United States Senate

The Honorable Richard E. Stickler
Acting Assistant Secretary of Labor
for Mine Safety and Health
Mine Safety and Health Administration
1100 Wilson Boulevard, 21st Floor
Arlington, Virginia 22209-3939

Please find enclosed copies of testimony and comments offered by Mr. Randall Harris and Mr. Jim Dean at the Federal Mine Safety and Health Administration's (MSHA) public hearing, regarding their newly proposed rules for underground shelters. Mr. Harris is a consultant to this office and Mr. Dean was the Interim Director of this agency, and continues to serve as the co-chairman of the state's Mine Safety Technology Task Force. The proposal about which they testified may severely impact the work that our state has done in order to protect the miners of West Virginia.

These comments follow the order of the subject's occurrence in the published proposal. The term shelter is used throughout these comments interchangeably with refuge. The published text is provide in *Times Roman Italics Font* for reference with comments in **Arial Font**

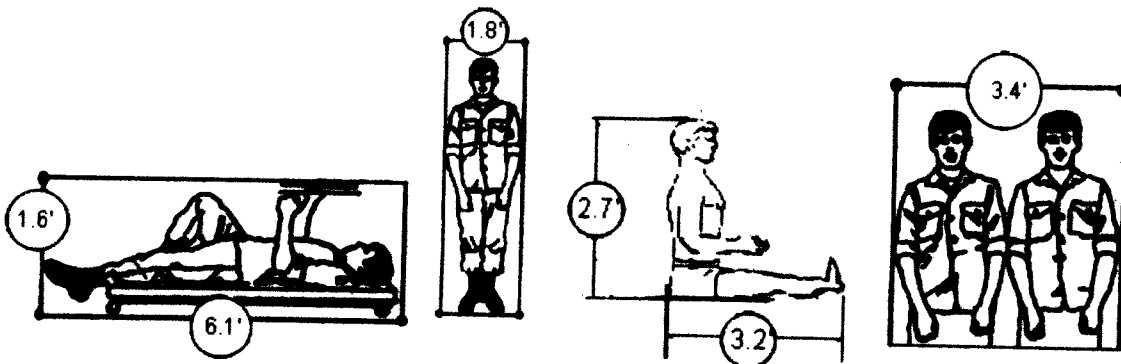
Section 7.505 Paragraph (a)(1) would require that refuge alternatives provide a minimum of 15 square feet of usable floor space and a minimum of 60 cubic feet of usable volume per person. MSHA believes that these proposed minimums are necessary to provide adequate room for miners using the refuge alternative. Usable space or volume means space or volume without stored items. The space and volume requirements are exclusive of the airlock space and volume. NIOSH design parameters requested 15 square feet and 85 cubic feet per miner. NIOSH stated that these recommendations were not to be considered absolute. Under this proposed provision, a space of 6 feet of length and 2.5 feet of width would amount to 15 square feet. If the same area has a height of 4 feet, the miner would be provided with 60 cubic feet of space. For mines with lower heights, the 60 cubic feet of space may need to be attained by increasing the length or floor area. MSHA solicits comments on these minimum space and volume requirements. Comments should be specific, including alternatives, rationale, safety benefits to miners, technological and economic feasibility, and supporting data. The area cannot be determined solely by the number of miners that would be using the refuge alternative. Miners would need some free space to operate components, drink, eat, and use the sanitation facilities—and tend to injuries. Additional space may be needed for suspended curtains, as part of a passive system CO₂ removal system. Also larger volumes seem to be more effective at dissipating heat.

This requirement is based upon a statement in the NIOSH report that was taken from a footnote in a 1986 report that referenced a 1958 Civil Defense publication (TB-5-3, May 1958). That document was researched by the NIOSH contract authors. If they had would have found it providing guidance for family fall out shelters that requested 80 cubic feet per person. It has no relevance to this application, a fact that has been confirmed to me by the NIOSH staff. If the MSHA staff would have called them they would have been told the same.

Fallout shelters were designed for occupancy by untrained civilians for periods of at least two weeks. Underground emergency shelters are designed for the survival of trained miners for a period of not more than 96 hours but most likely less than 48 hours.

Images taken from the US Department of Defense Human Engineering Manual (MIL-HDBK-759C) and modified to indicate English units verse Metric units.

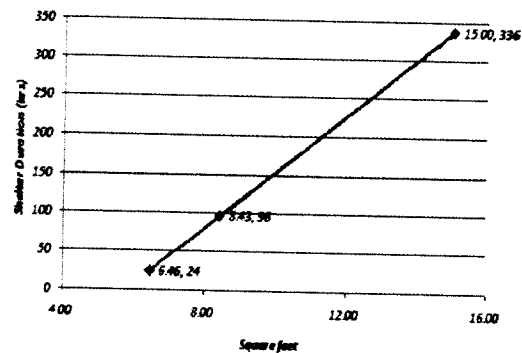
The US Department of Defense Human Engineering Manual (MIL-HDBK-759C) indicates that a supine man should have a space of 1.6 feet high by 6.1 feet long. It defines the space required for a man sitting to be 2.7 feet high by 3.2 feet long. If we assume that these are the two extreme positions in a shelter, we get a maximum volume of 29.6 cubic feet and a floor space of 10.9 square feet. (This value is arrived at by using the height of the sitting man, the length of the supine man and the design shoulder width.) As a point of reference, the South African regulation is 6.4 square feet of floor space with no volume value (Chief Inspector of Mines Directive B5, 14 Feb. 1994).

Since low-coal mines can result in interior shelter heights of 2 feet, the sitting position would not be applicable. In those situations, the volume would be limited to that of the supine position with a volume requirement of 17.6 cubic feet.

Additionally, the Department of Defense document identifies as 3.4 feet the space required for two men, which provides some guidance for the number of miners in given shelter length.

I: Pressure history of high explosive (HE) and thermobaric explosive (TBE) detonations

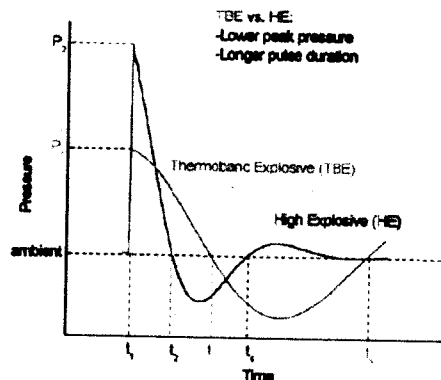
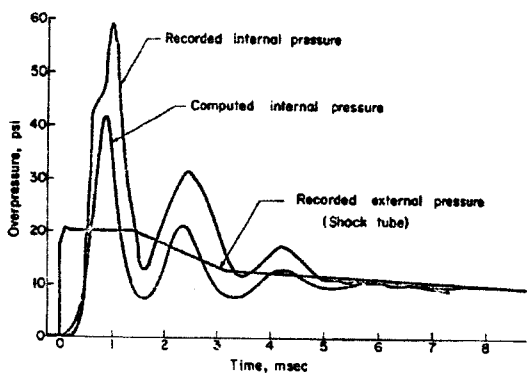
Agree. As discussed in the Comment 11 the period listed in the text is 0.2 seconds. This is effectively a static load and provides multiple means of testing. While there has been discussion of using a period in the few millisecond range, the seminal study on the subject of human effects of blast waves, "The Biodynamics of Airblast" by Clayton S. White, et al sponsored by the Defense Nuclear Agency in 1971, indicates that in closed environment such as building or mines that wave reflection and wave stacking result in not only higher effective overpressures but prolonged durations. An overpressure event of 15 psi in mine entry could easily produce an effective duration exceeding 0.5 seconds that would not affect the design criteria for a shelter but would increase the trauma of anyone in the blast zone.

Additionally the internal amplification of the overpressure due to wave stacking within the body found was found in these studies. An external pressure of 20 psi resulted in an in-lung pressure of 60 psi (see page 77 of the above report). The cause of fatality in animal studies has shown to be damage to the lungs.

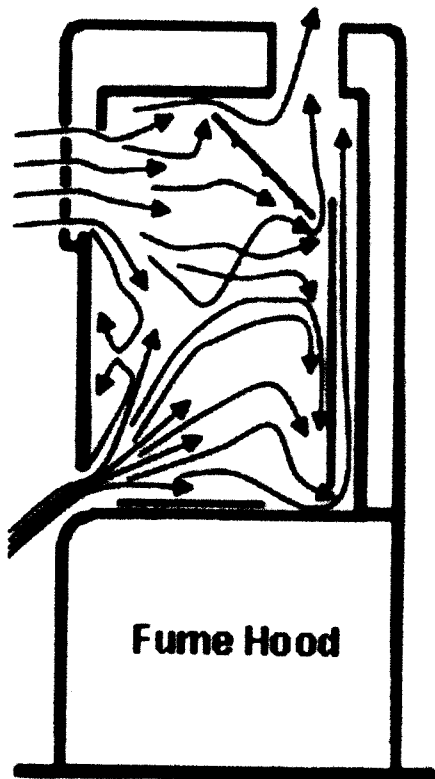
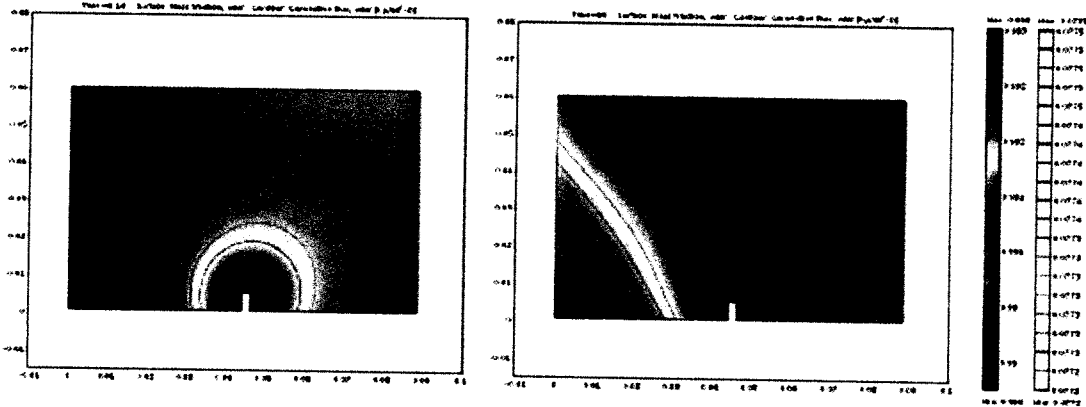
MSHA considered the enclosed space as similar to a loose-hood respirator using supplied air. Flair Corporation Bulletin 270 revision H (4-01) indicates that OSHA requires a supply air of 6 to 15 cfm (360 to 900 cfm) for supplied air hoods (continuous flow supplied air respirators) to purge accumulated carbon dioxide. The 12.5 cfm per person fell within this range. Engineering handbooks recommend ventilation rates in the range 10-15 cfm of fresh air per person for offices with 12.5 cfm per person being the midpoint of this range. MSHA believes that these quantities are conservative. However, they are design parameters for a life support system, which demands a more cautious approach. In addition, compressor wear reduces performance and the system will become less efficient with age. The Agency considers that the use of compressed air cylinders as the sole means of providing breathable air may be impractical and encourages mine operators to consider other options. As MSHA pointed out in PIB P07-03, a fan or equivalent method should be used to force fresh air into the hole with enough positive pressure to overcome total mine pressure to deliver sufficient quantities of breathable air. Compressor air intakes should be installed and maintained to assure that only clean, uncontaminated air enters the compressors. Mines should assure compressors have the capacity to deliver the required volume of air at the point of expected usage.

Open circuit respirators such as the one used in this analogy are designed with great care to ensure that the flow of air routes any contaminants in such a manner that they do not become trapped with the space. The document referenced could not be found however, the laboratory fume hood a more appropriate analogy. It is designed to ensure sufficient ventilation of large space such that hazardous gases are continuously removed from all corners of the space. The airflow and surfaces are designed to ensure sufficient turbulence of the high airflow (125 cfm) within the hood to ensure sufficient movement to carry any hazardous compounds from the space. This is a good analogy for what is needed to happen if an inflatable stopping were erected in a hazardous environment and the space needed to be purged.

Supplied air respirators such as the personal protection hood referenced in the MSHA text cover the head with an open flap along the shoulder and chest. Air is injected at the top rear of the head and works its way through the space toward to opening. The distance between the head and the inside of the hood is small and while the air flow is complicated, the possibility of leaving pockets of

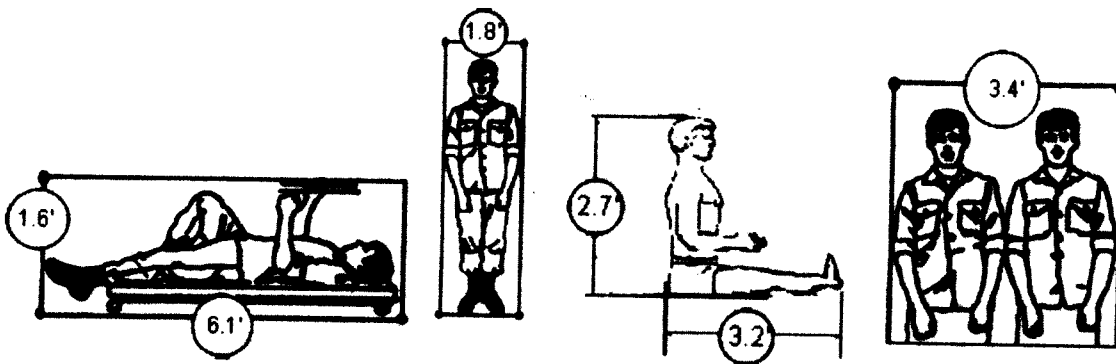
This requirement is based upon a statement in the NIOSH report that was taken from a 1958 Civil Defense publication (TB-5-3, May 1958) providing guidance for family fall out shelters that requested 80 cubic feet per person. It has no relevance to this application.

Fallout shelters were designed for occupancy by untrained civilians for periods of at least two weeks. Underground emergency shelters are designed for the survival of trained miners for a period of not more than 96 hours but most likely less than 48 hours.

The net effect of this provision would be reduce the effective occupancy of current shelters by up to 50% and more than double their number underground. This increases

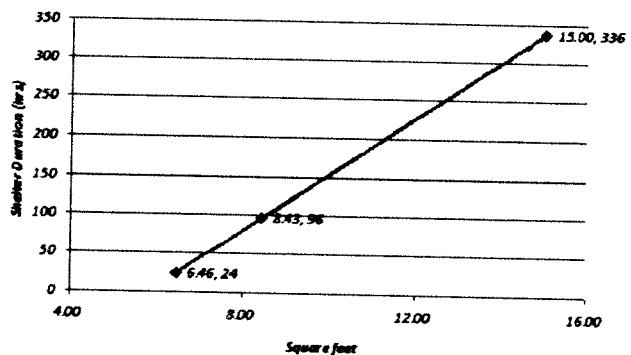
Another approach that has been requested by some could be to extrapolate between the values utilized in South Africa mine shelters since the 1990's of and those of the U.S. Navy for 100 men in fallout shelters for 14 days. Using the approach in graph on below this would result in a value of 6 square feet.

However, it is important to remember that emergency shelters are the last resort in the event of an accident to ensure survival not to ensure comfort. As one miner told me after a training session on all the things we have done to improve their chances for escape, "With all these extra escape additions if I have to, the decision to get into a shelter or not boils down to the shelter or a body bag...it's not that a hard a choice." Comfort is not the main consideration...survival is the ONLY consideration.
